Addendum #1

Big Springs Trout Hatchery Residence #2035

Date: 6 December 2023
BSPARK Proj. No.: 20011

A102

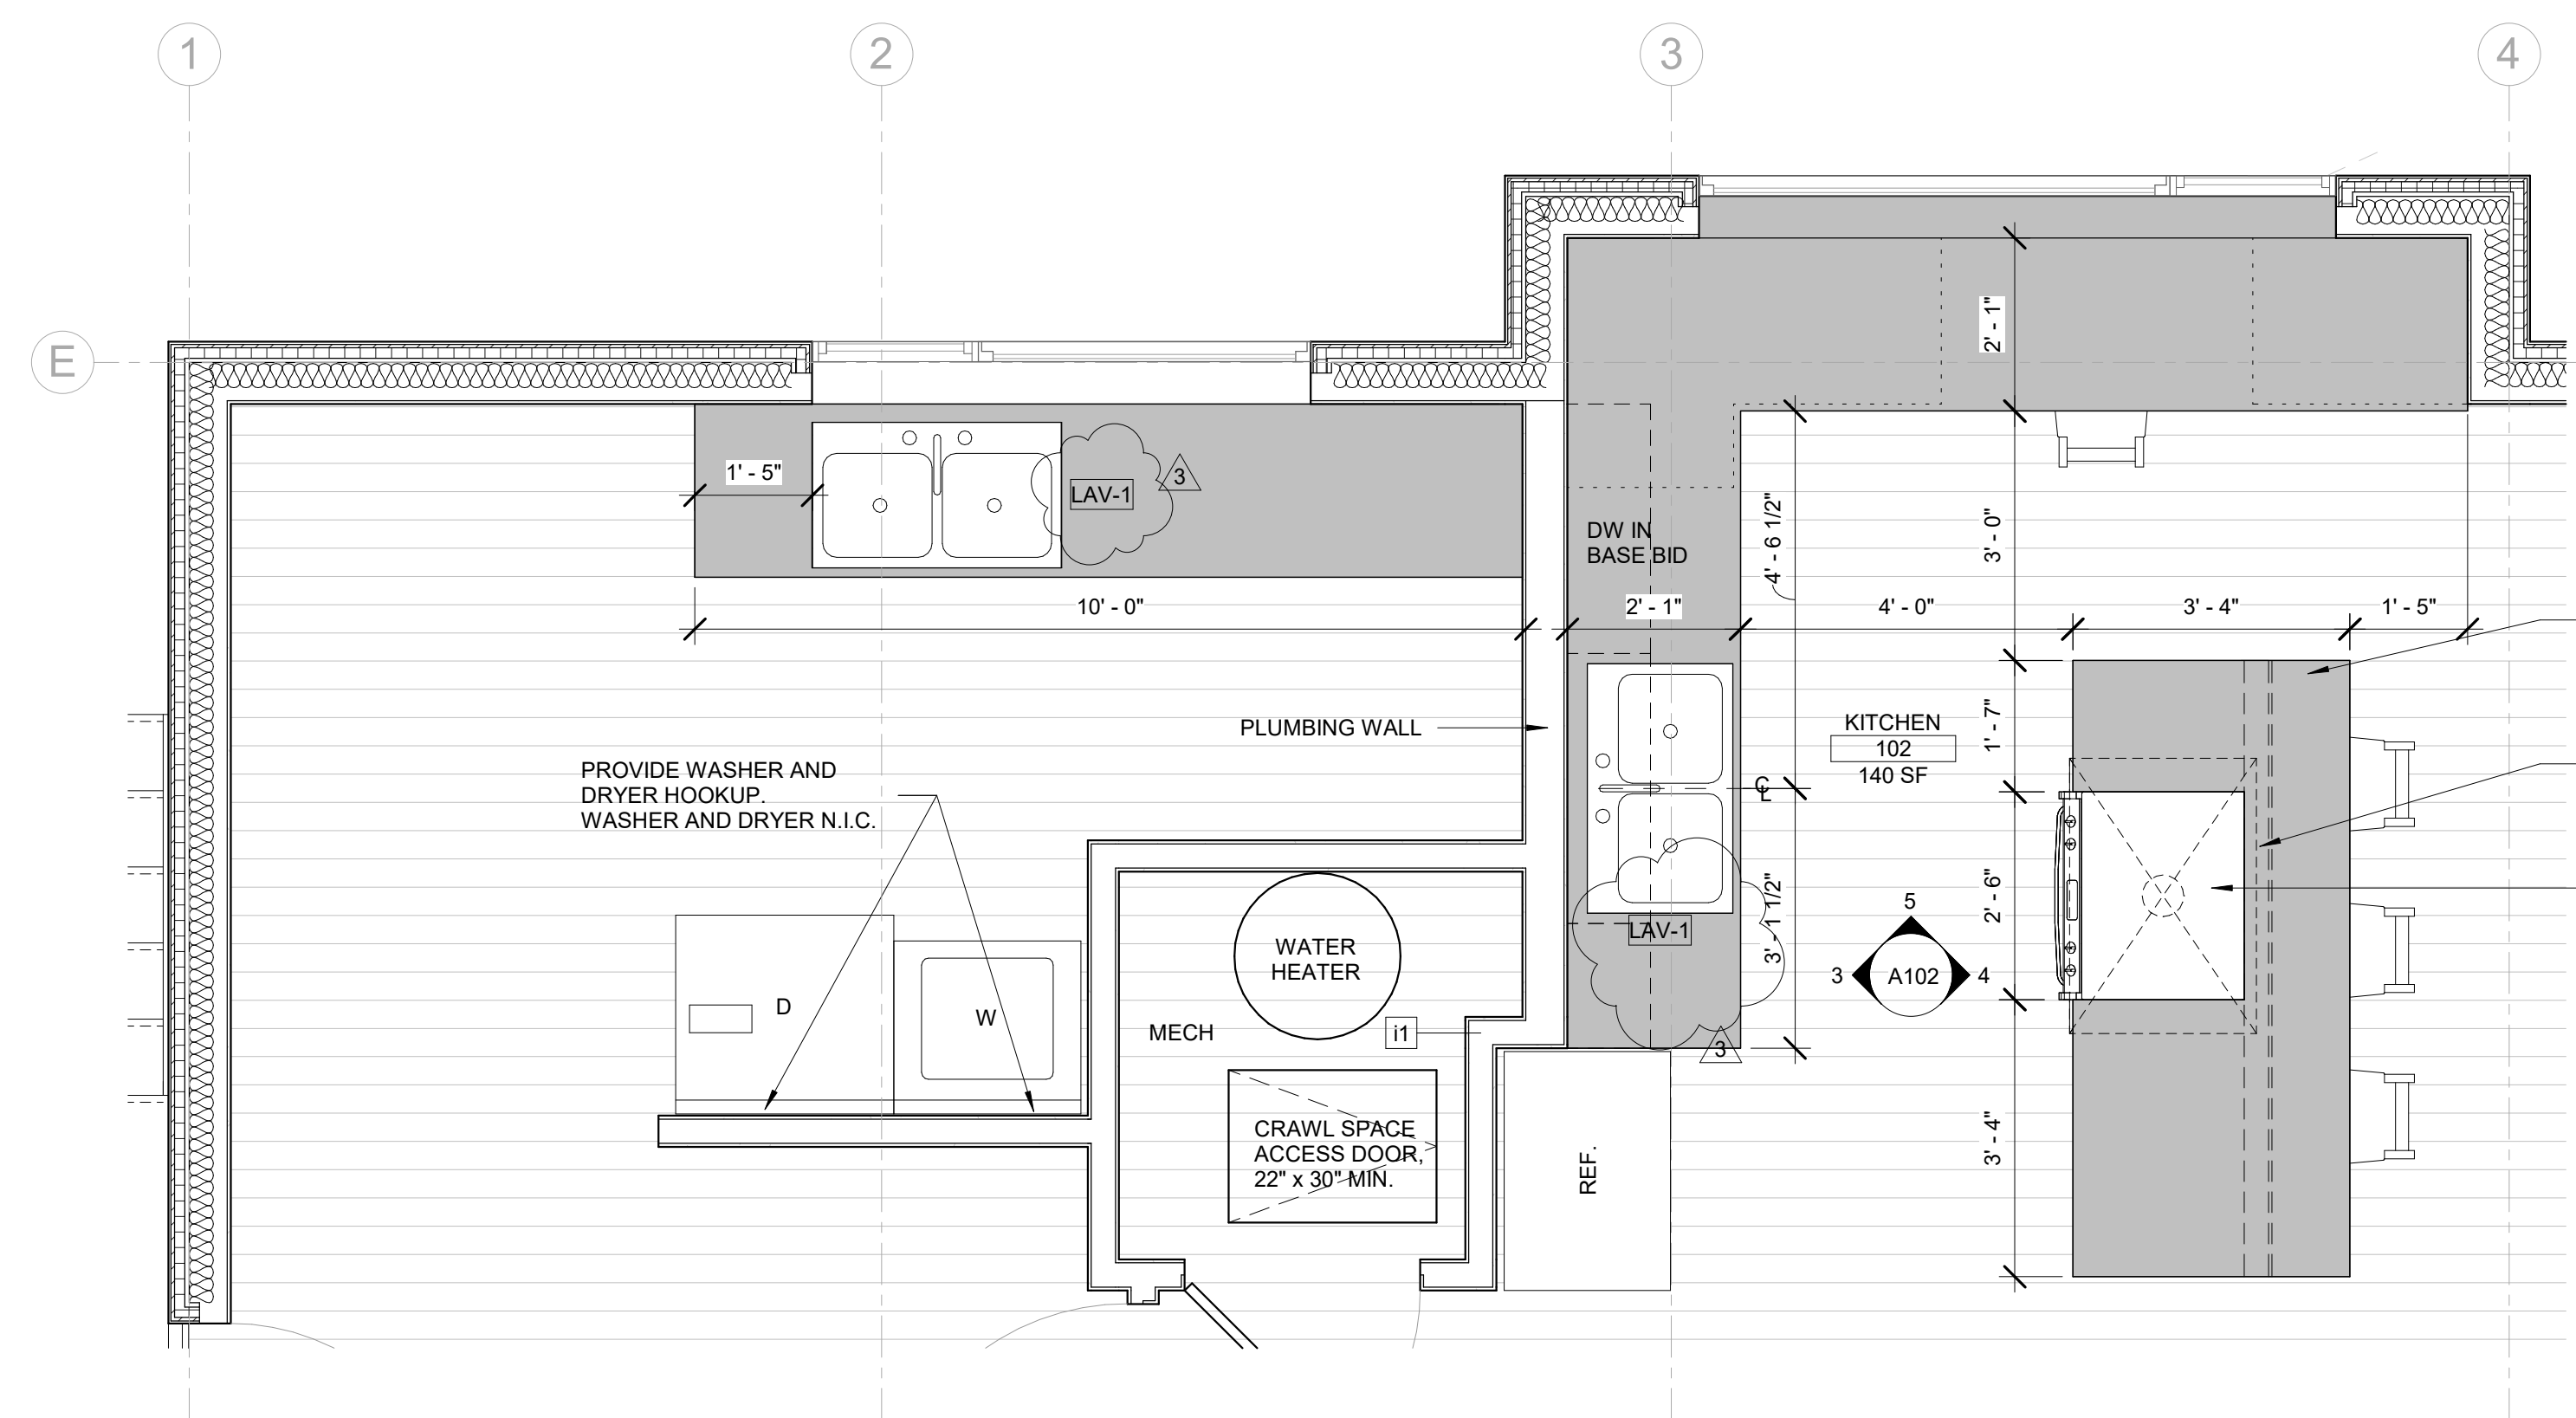
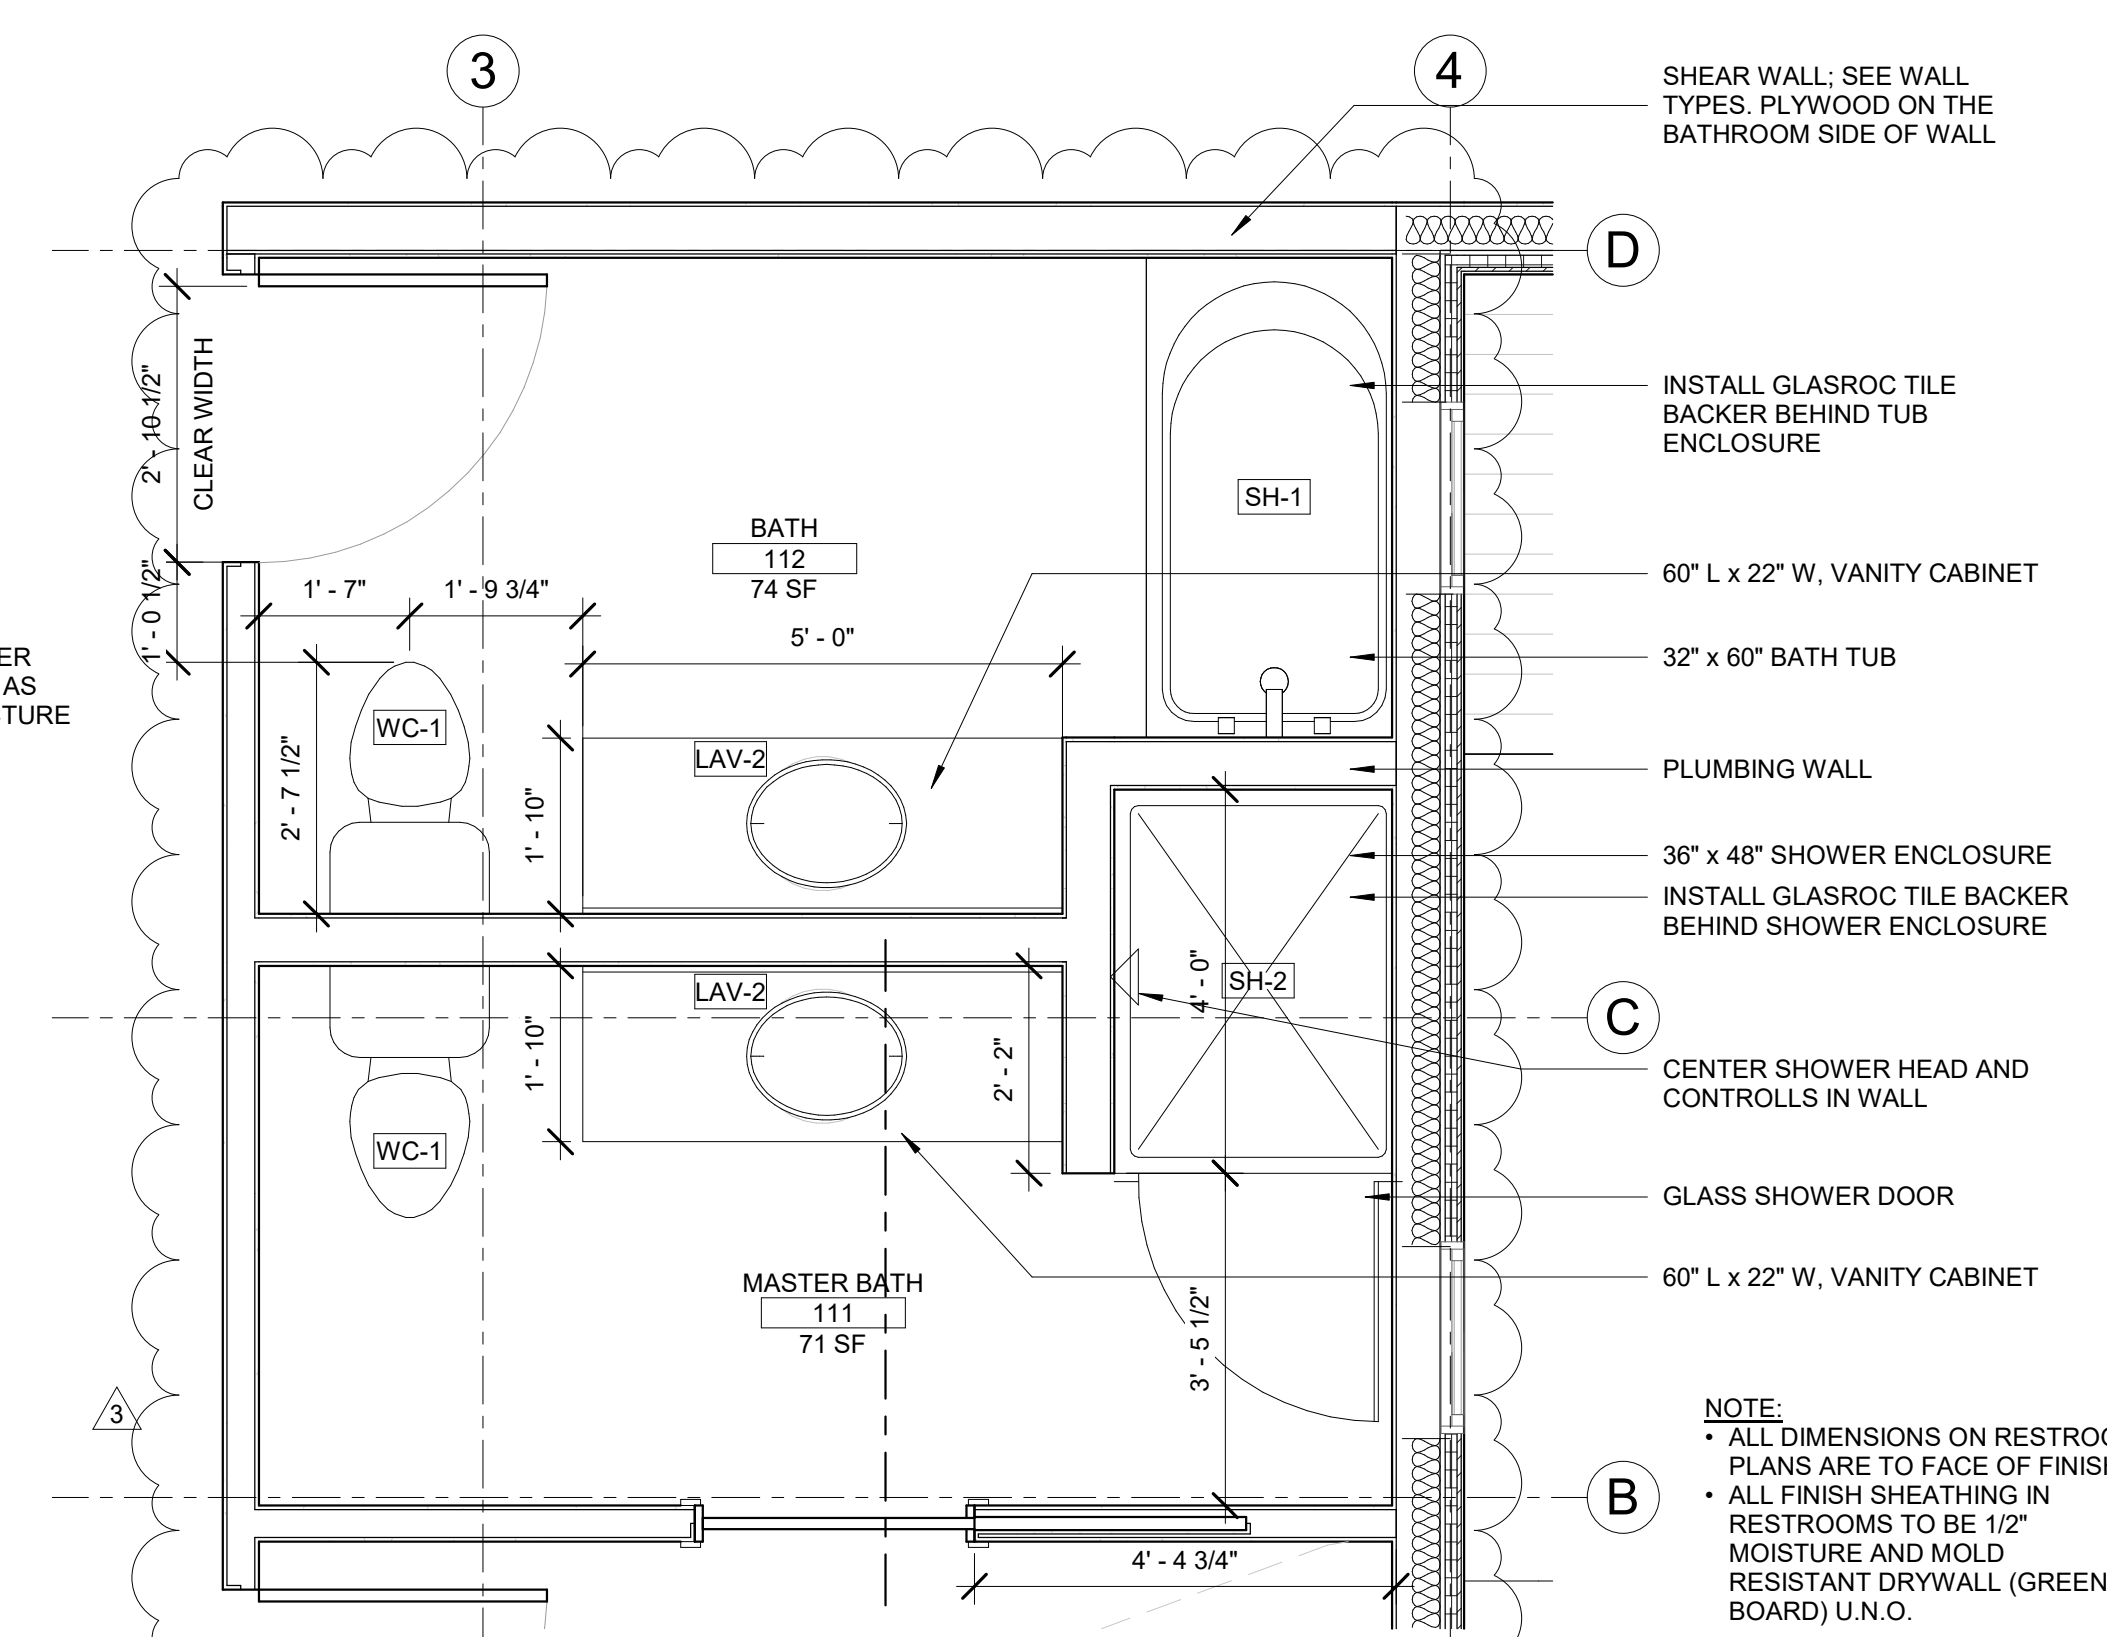
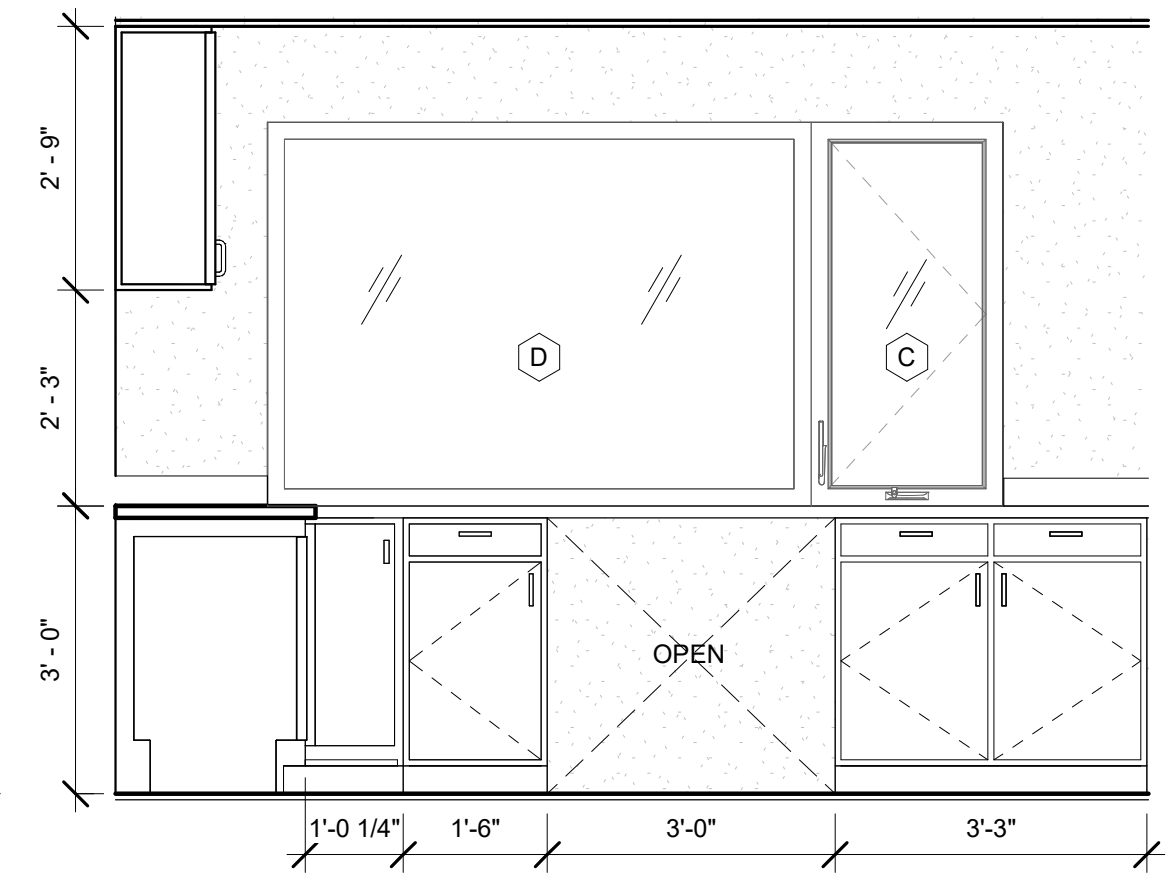
1. Light fixtures Basis-of-design added.
2. Plumbing fixture Basis-of-design added.

SYMBOL	FIXTURE	MANUFACTURER	FINISH	MODEL #	LOCATION	COST	QUANTITY	LINK
WC-1	Bradenton 1.28 GPF One-Piece Skirted Elongated Toilet - ADA Compliant	SIGNATURE HARDWARE	WHITE	447349	BATHROOMS	509	2	https://www.build.com/signature-hardware-948414-12-1/s1712993?uid=4046013&searchId=I7d67N7V4W
LAV-1	Double Basin Kitchen Sink	AMERICAN STANDARD	STAINLESS STEEL	18DB.9321800T.075	KITCHEN, LAUNDRY	282	2	https://www.build.com/american-standard-18db-9321800/s1299037?uid=3091601&searchId=nQRO4bxGNB
	Single Hole Pull Down Faucet	KOHLER	MATTE BLACK	K-596-VS	KITCHEN, LAUNDRY	283	2	https://www.build.com/kohler-k-596/s563679?uid=1770065&searchId=MvGBAseUIC
LAV-2	Studio Drop-in Bathroom Sink	AMERICAN STANDARD	WHITE	643001.02	BATHROOMS	220	2	https://www.build.com/american-standard-0643-001/s1068446?uid=2575949&searchId=5PKpUzUzC

1.2 GPM Single Hole Bathroom Faucet	AMERICAN STANDARD	MATTE BLACK	7353101.243	BATHROOMS	245	2	https://www.build.com/american-standard-7353-101/s1236102?uid=4538759&searchId=bYVGMvAJoy
SH-1	New Solar Collection Bathtub 30x60"	AMERICAN STANDARD	WHITE	263112.02	BATHROOMS	446	1	https://www.build.com/american-standard-0263-112/s821115?uid=2114385&searchId=2C6THZ11W
	Studio S Shower System, 24" Height	AMERICAN STANDARD	POLISHED CHROME	S-SV-3.002	BATHROOM	471	1	https://www.build.com/american-standard-studio-s-sv-3/s1708391?uid=4033624&searchId=rqBuhR1VpU
SH-2	Acrylic Backwall Shower Kit	DREAMLINE	WHITE	SHBW-1536760-00	BATHROOM	530	1	https://www.build.com/dreamline-shbw-1536760-00/s1832604?uid=4345973&searchId=uxPnT04AKB
	Frameless Pivot Shower Door	DREAMLINE	SATIN BLACK	SDAD345720VXX09	BATHROOM	630	1	https://www.build.com/dreamline-sdad345720vxx/s1824873?uid=4330858&searchId=5JToId6HX
	Studio S Shower System, 24" Height	AMERICAN STANDARD	POLISHED CHROME	S-SV-3.002	BATHROOM	471	1	https://www.build.com/american-standard-studio-s-sv-3/s1708391?uid=4033624&searchId=rqBuhR1VpU
